AMENDMENT TO THE DRAWINGS

REMARKS

Figure 7

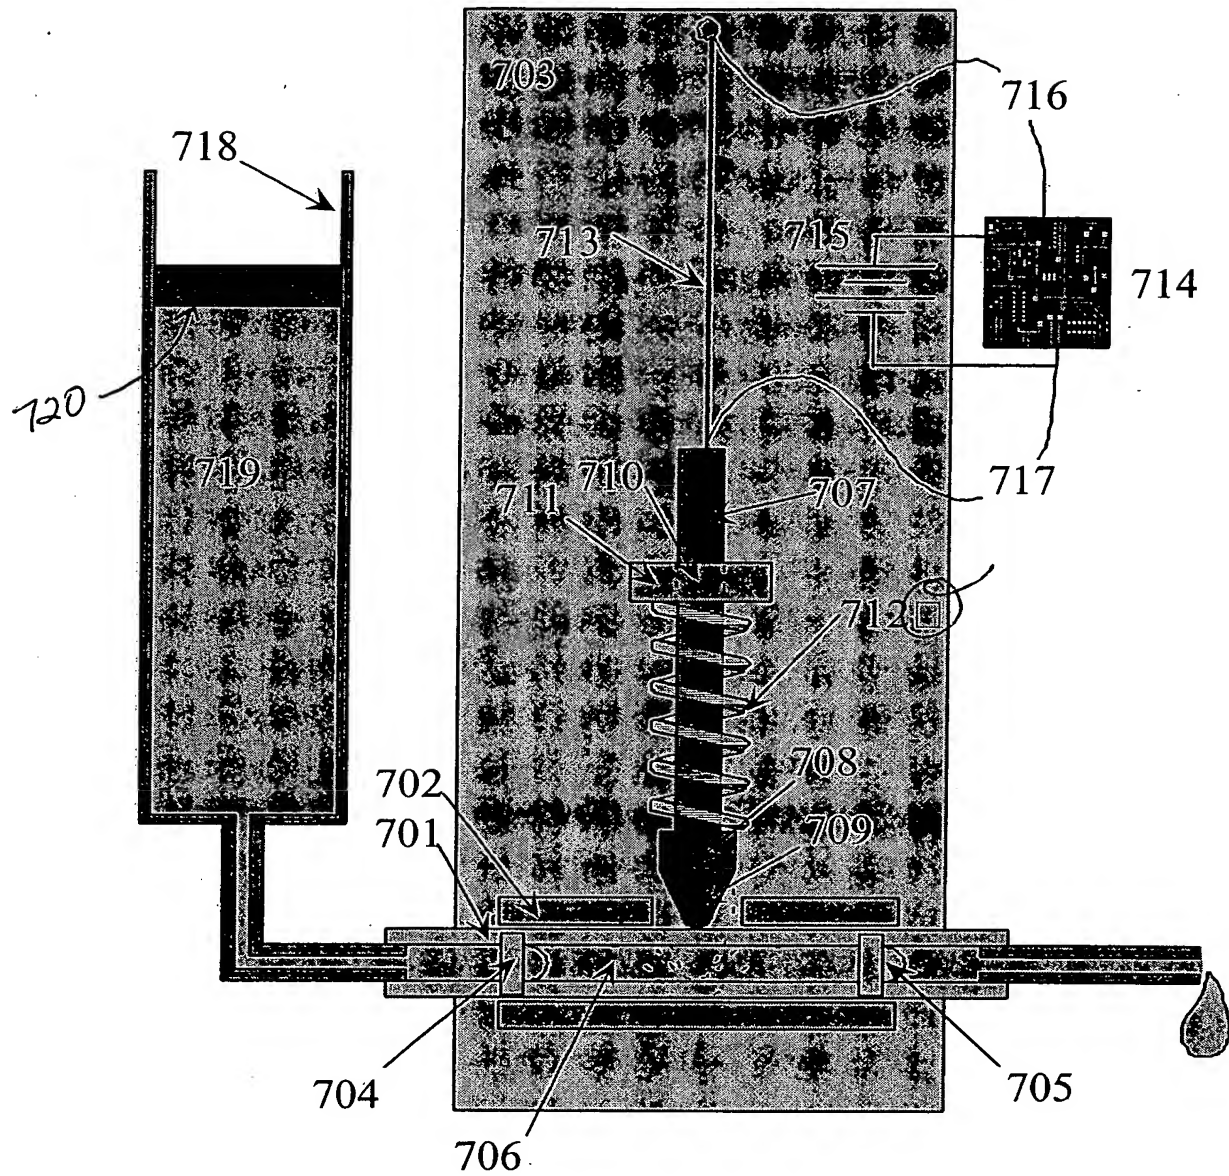
The attached replacement sheet includes changes to Figure 7. This replacement sheet that includes Figure 7 only replaces the original sheet that includes Figure 7 only. The attached annotated sheet is marked to show the changes made.

The drawing of Figure 7 has been amended to correct an obvious oversight in the appearance of a "□" symbol following reference number 712 in original Figure 7. As amended, the drawing of Figure 7 is consistent with the specification, for example, paragraph [0046] of the specification. Additionally, a new reference number 720 has been added, as is consistent with the amendment of paragraph [0047] of the specification, as described above. No new matter has been added by virtue of this amendment.

amended, the specification refers to two reference numbers, 718 and 719, and to a new reference number 720, as is consistent with the replacement Figure 7, as further discussed herein. No new matter has been added by virtue of this amendment.
